City Plan Commission Agenda
October 10, 2023
Reedsburg City Hall Council Chambers
6:00 PM

- A. Consider variance as part of subdivision plat review to allow a cul-de-sac street per § 674-7(D)(5). 1351 8th St; parcel #276-2031-00000 – Third Act Development, LLC
- B. Consider Site Plan Review for a new 106' X 54' Reedsburg Flooring building and parking lot – Corner of Greenway Ct & Zinga Dr; Parcel # 276-2243-11000 – D2 Property Construction LLC (Freeman Decorah)
- C. Consider recommending Planned Development Group for nine new townhouse and one duplex – S. Dewey Ave between E Main St & Plum St; Parcel #s 276-1313-20000 & 276-1313-30000 – D2 Property Construction LLC (Freeman Decorah)
- D. Consider recommending property rezone from R-3 Residential to B-3 Business per § 690 Schedule 1 – 420 Plum St; Parcel #276-1640-20000 – Dan DeBaets

1 FIRST FLOOR PLAN
SCALE: 1/16" = 1'-0" on 11" x 17"
1/8" = 1'-0" on 22" x 34"

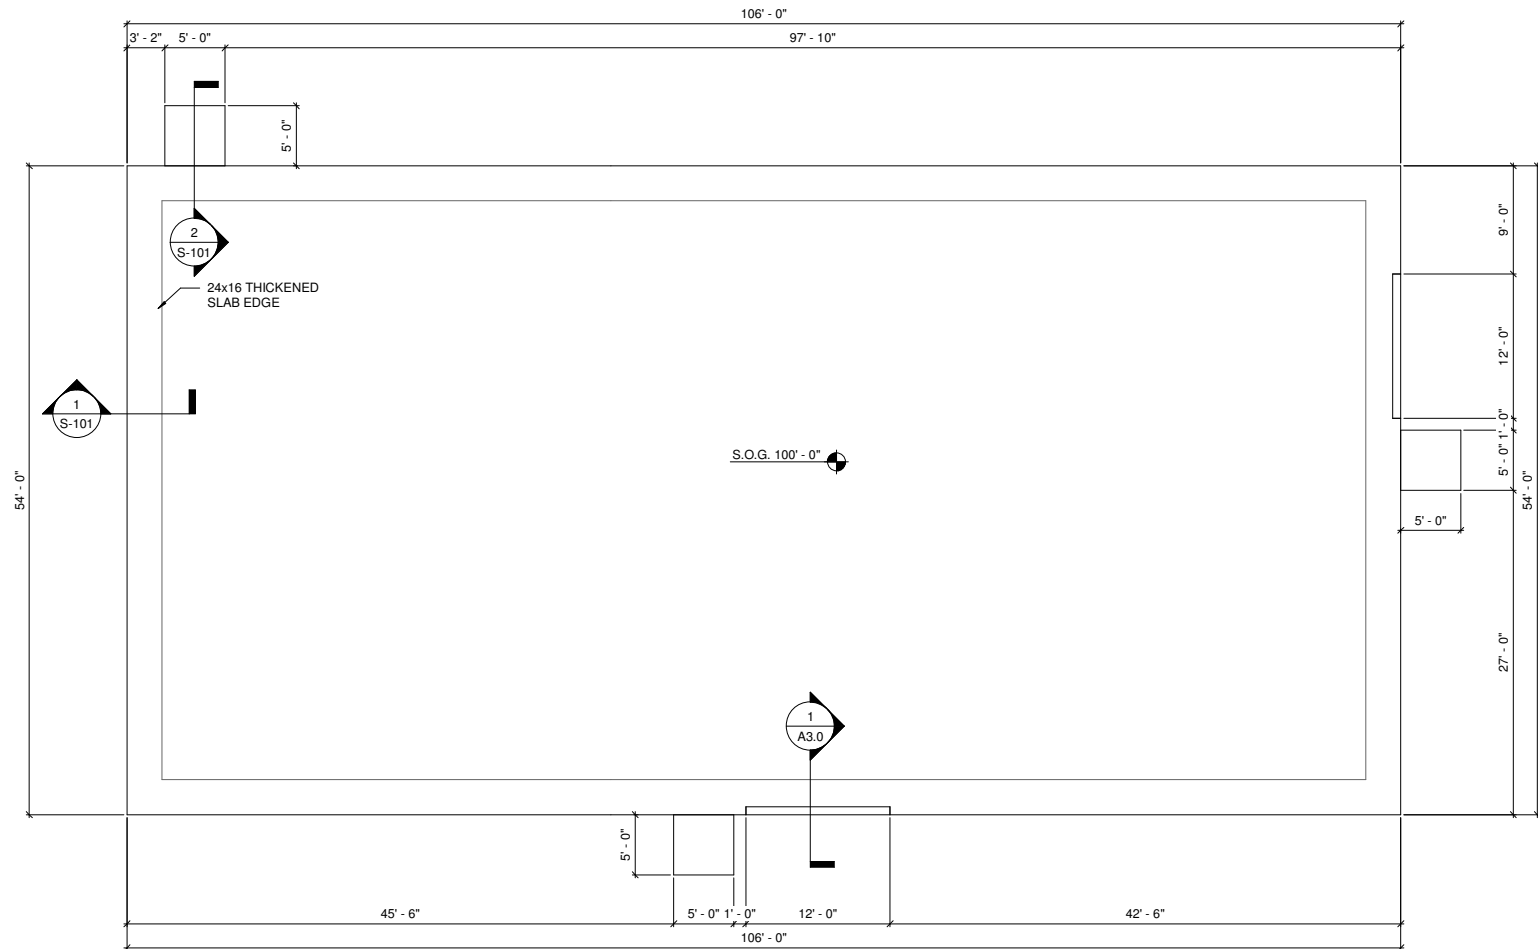
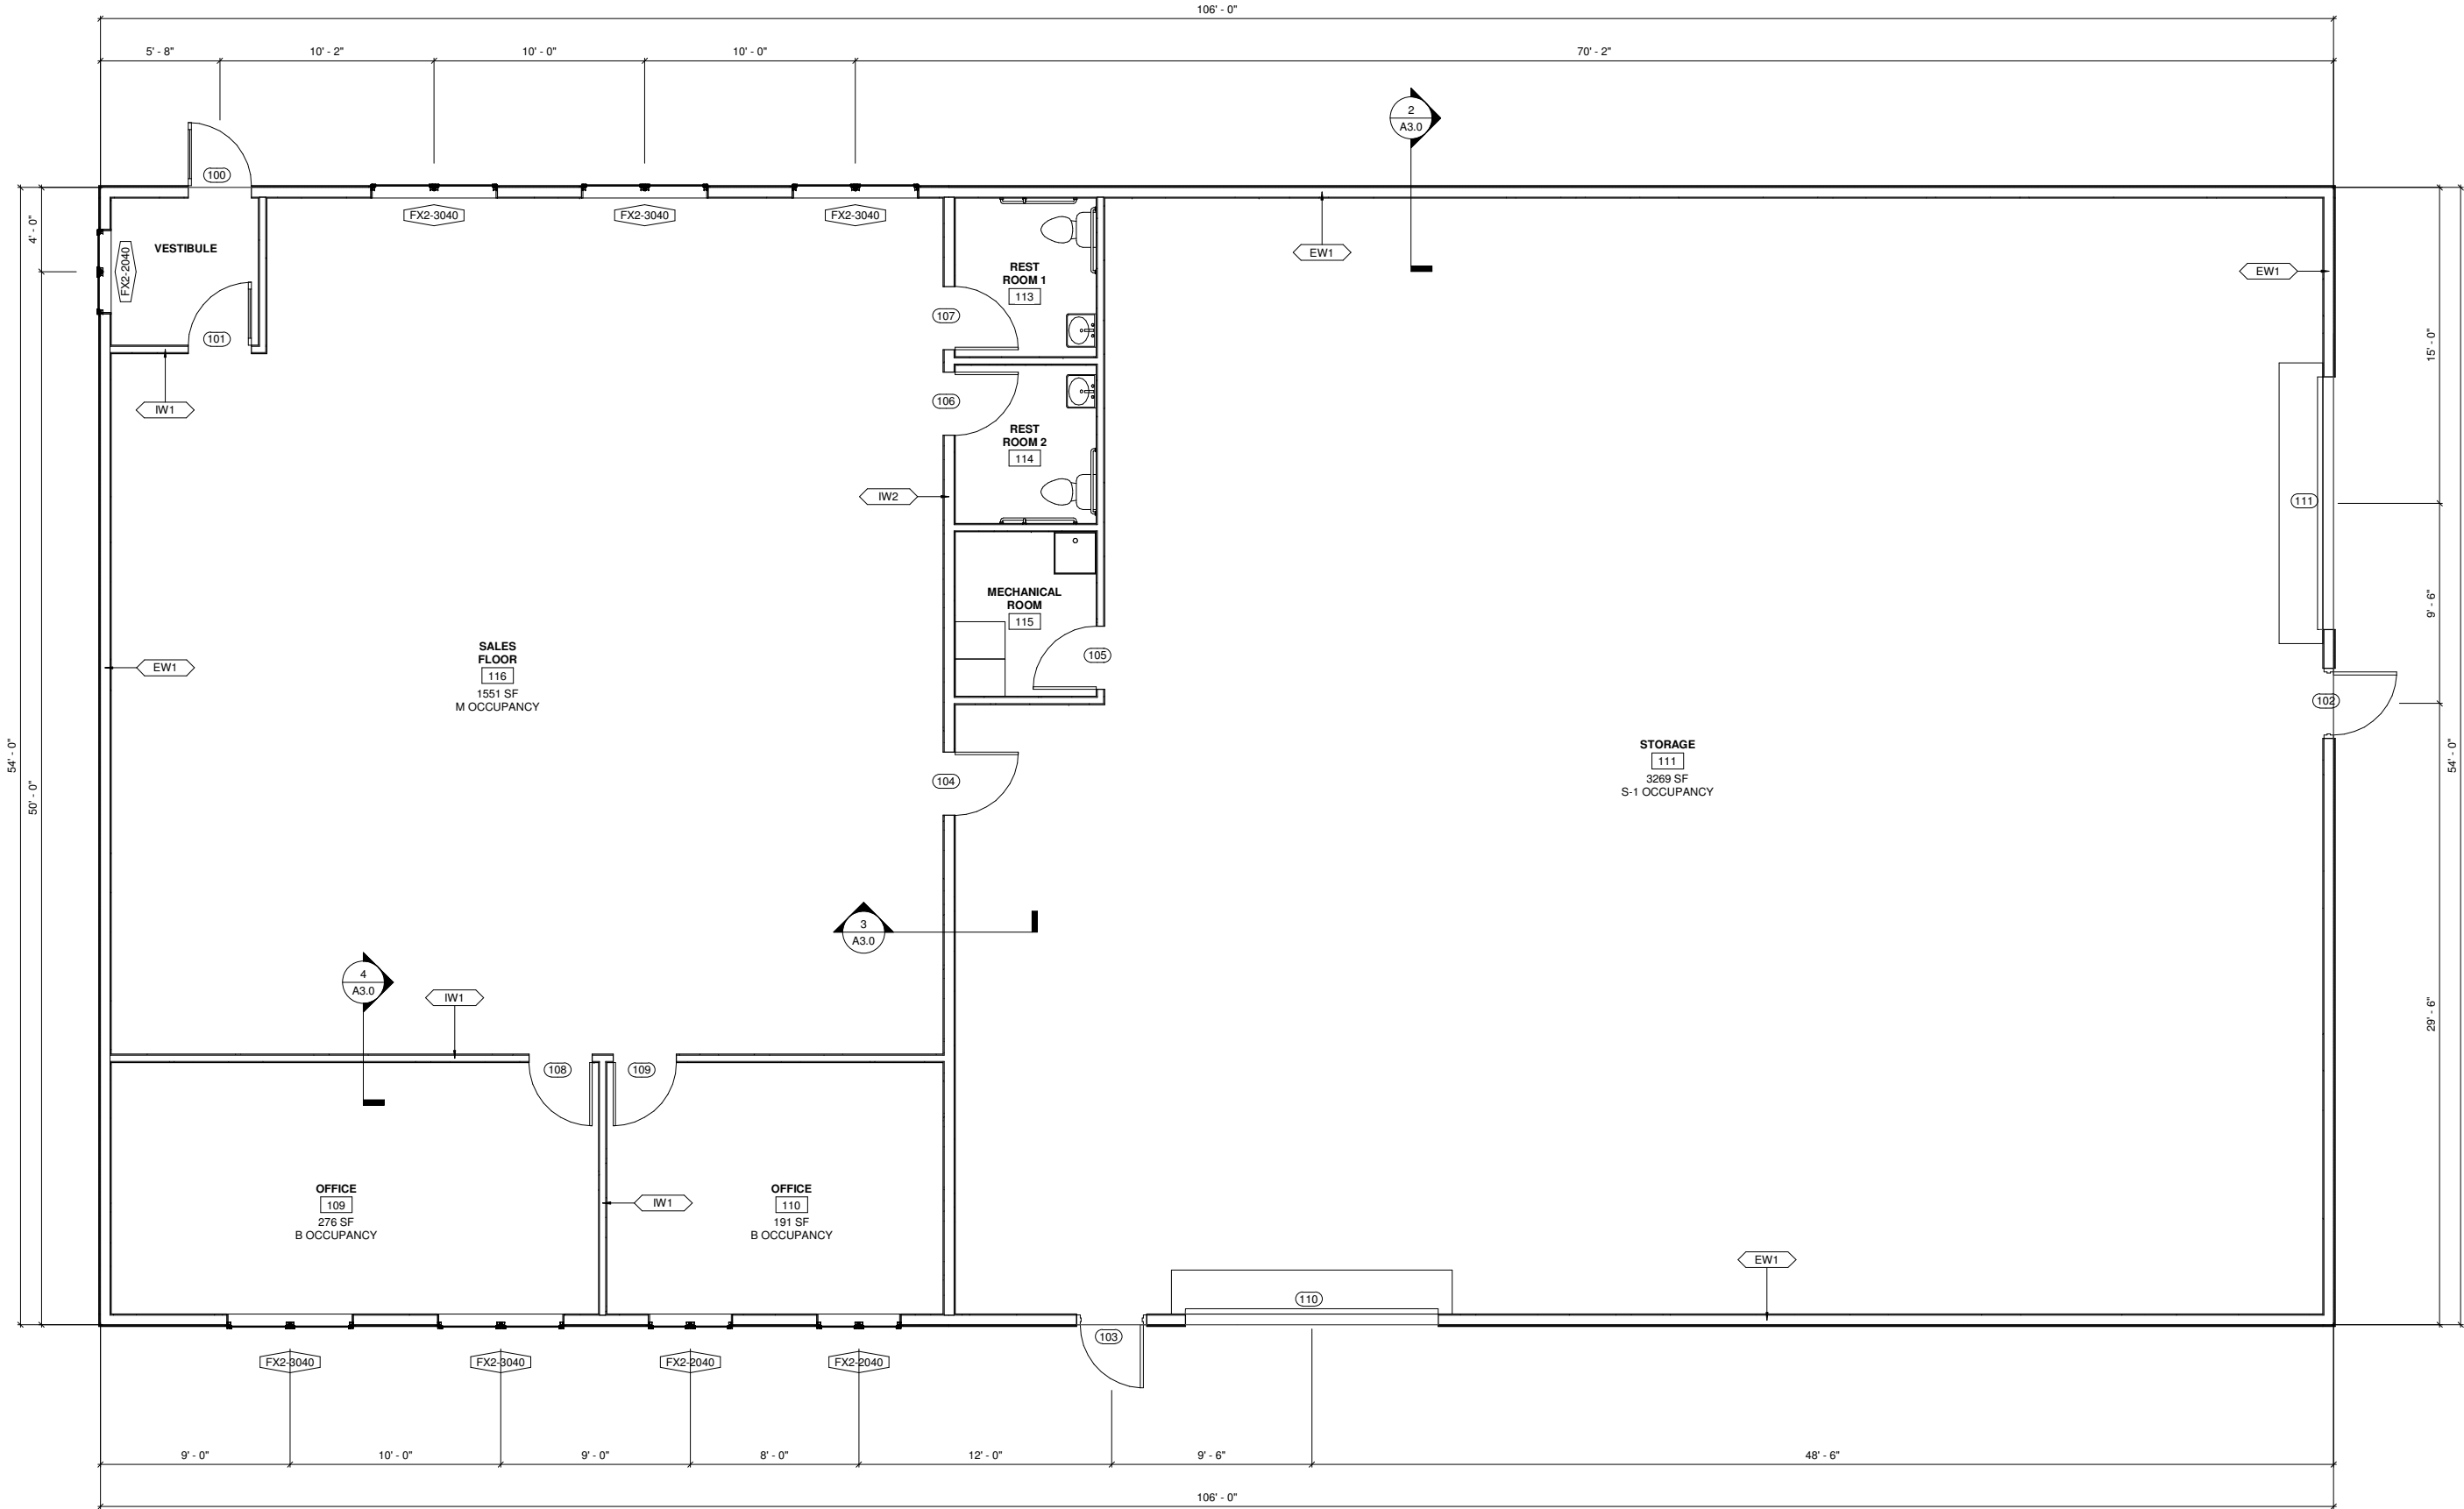
- Parking spaces shall be at least 10 X 18 (9 X 18 are on the plan)
- The driveways on the site plan do not seem match the location on the building plans

- Landscaping is proposed along the west and north lot lines and shall meet §690-67(G)(10)
 - *(a) The setback area abutting streets shall be landscaped with a combination of deciduous canopy trees, shrubbery and ground cover. At least one tree at least six feet in height for each 50 feet of street frontage shall be planted in the setback area. Any buffer zone, shall be a minimum of 40 feet wide and planted with plant materials at least six feet in height of such variety and growth habits as to provide a year-round, effective screen for the abutting residential properties. All off-street parking areas that serve 20 vehicles or more shall be provided with landscaped areas totaling not less than 5% of the surfaced area.*

SITE CONCEPT
KMD DEVELOPMENT - NINE UNIT & DUPLEX
CITY OF REEDSBURG
SAUK COUNTY, WI

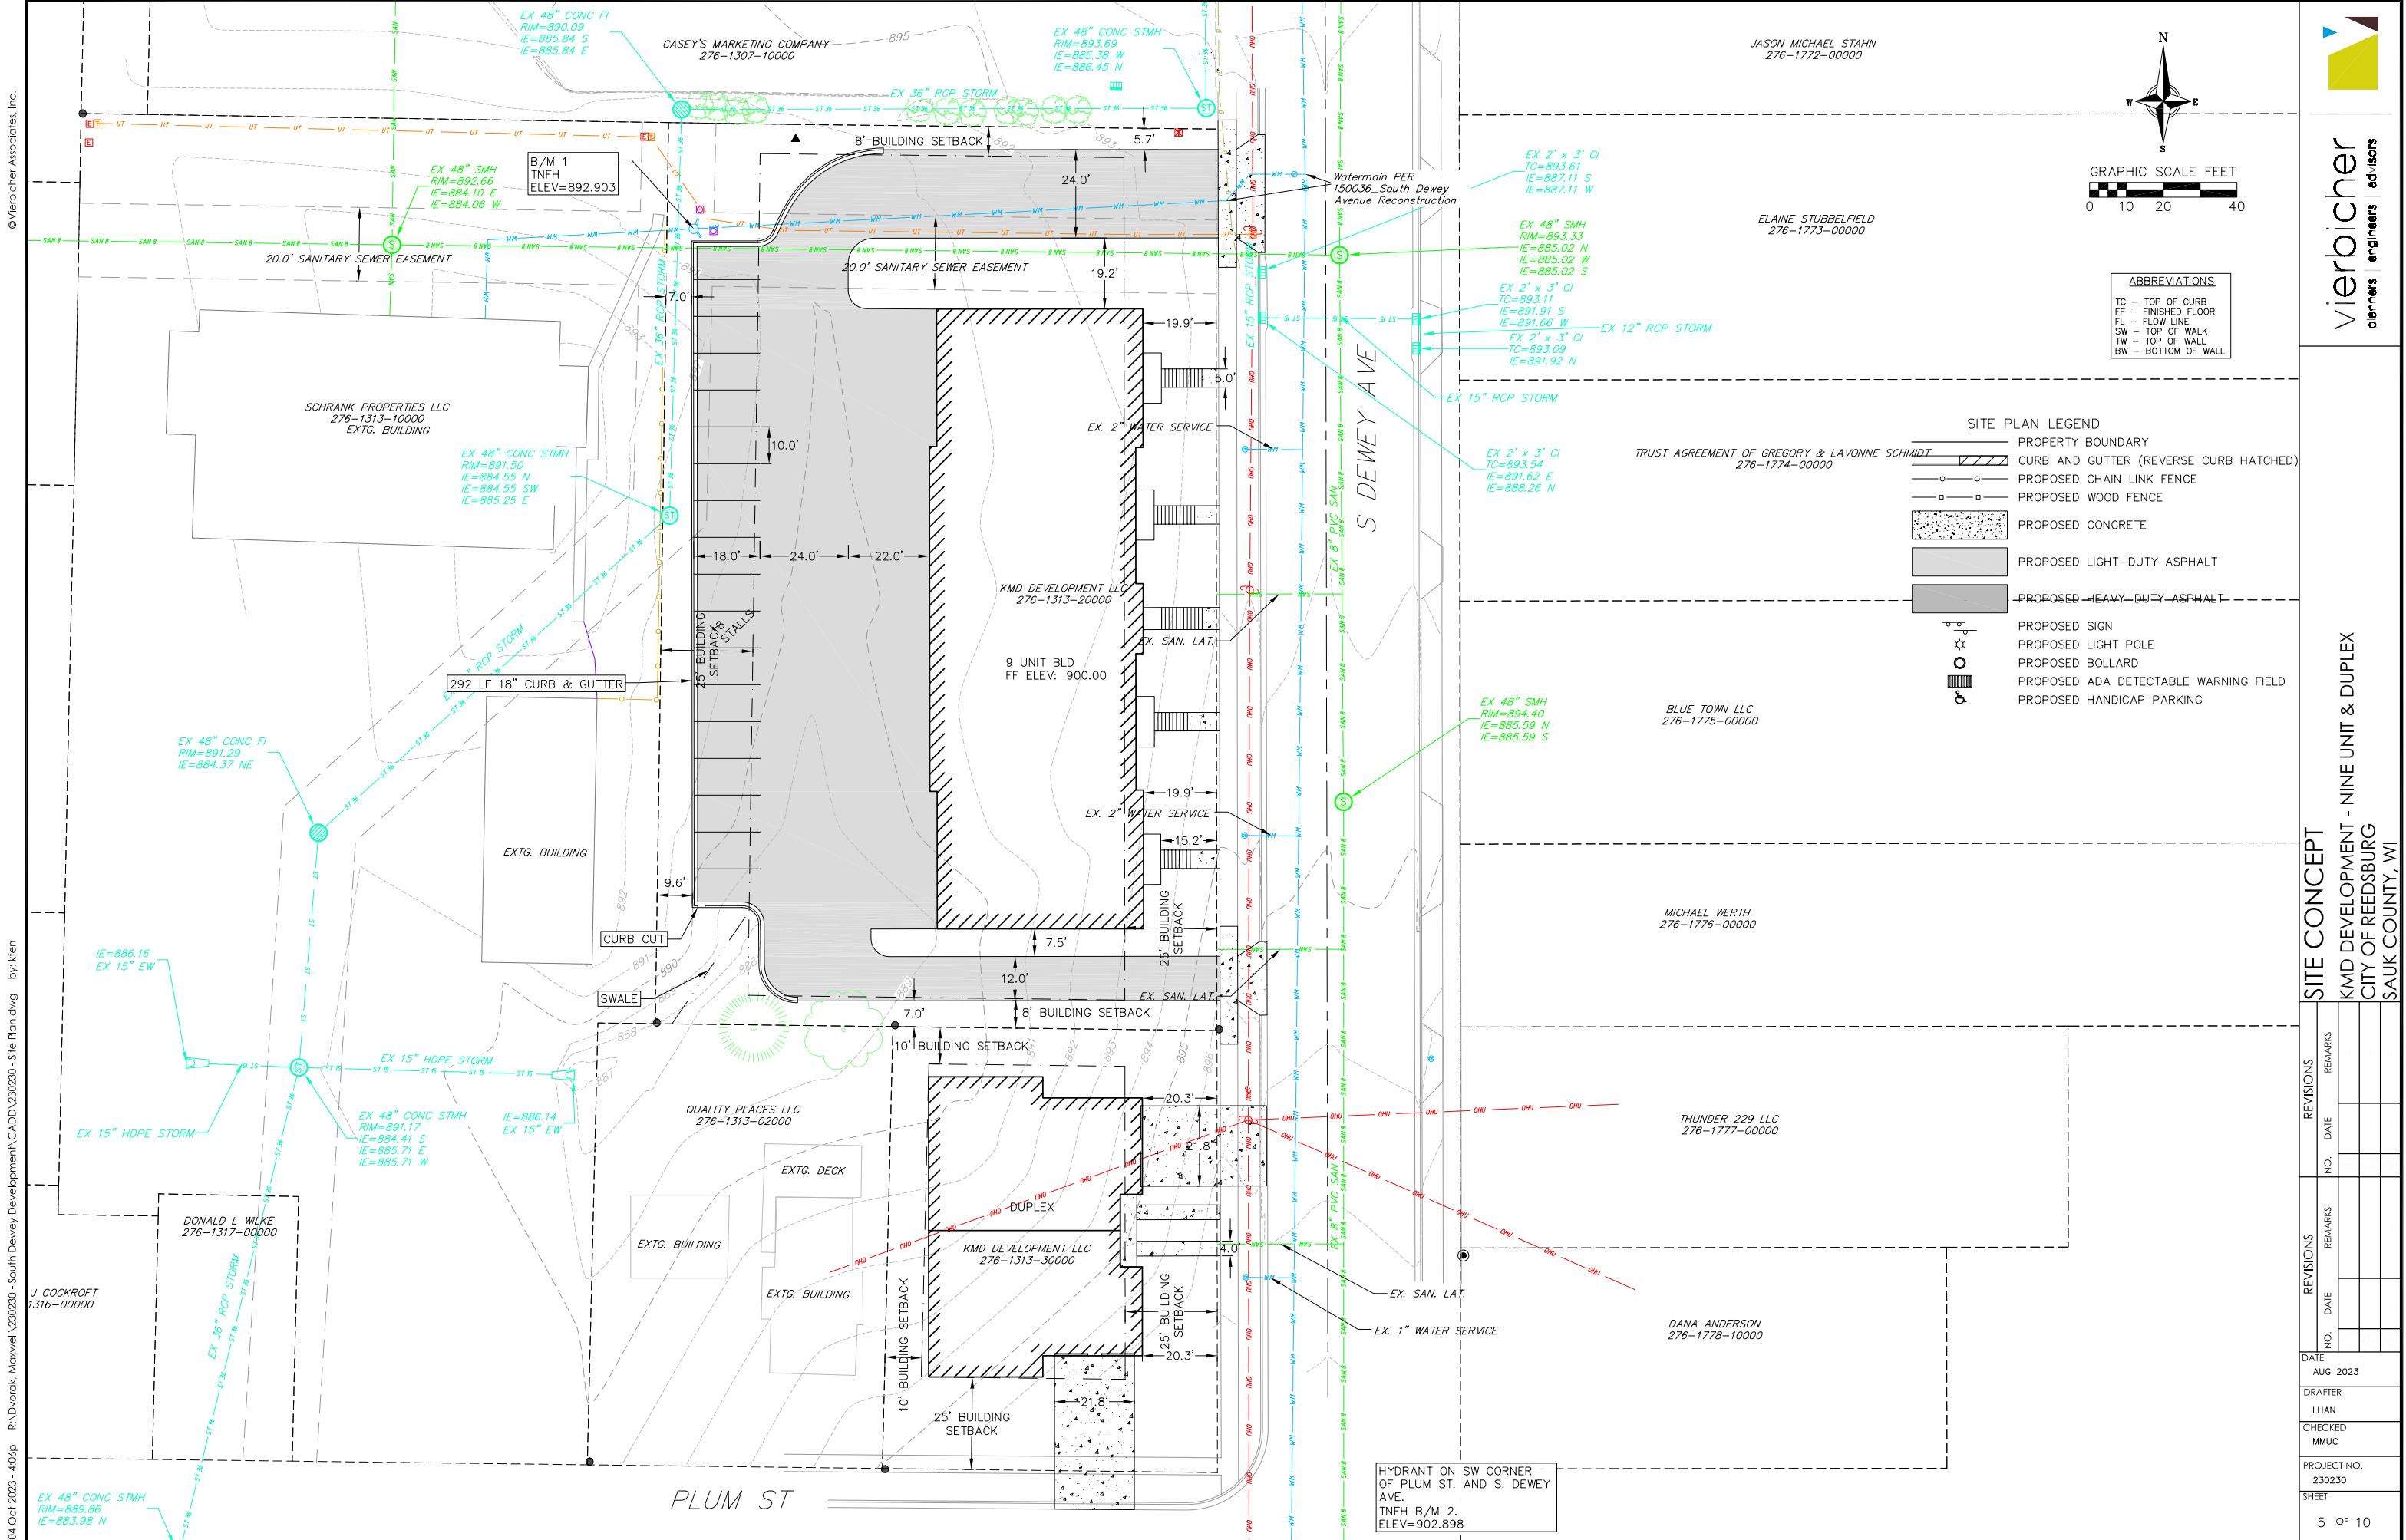
- Waivers are needed for the rear setback of the duplex and front setback of the townhomes. And possibly for the amount of green space. Therefore council approval is required thru PDG.
- There is no stormwater indicated on the plan.
- Having the parking in the rear improves the aesthetics.
- Landscaping should be added along the west lot line.
- If the townhomes are divided in the future (zero lot line), then the residential trash & recycling bins can be used.
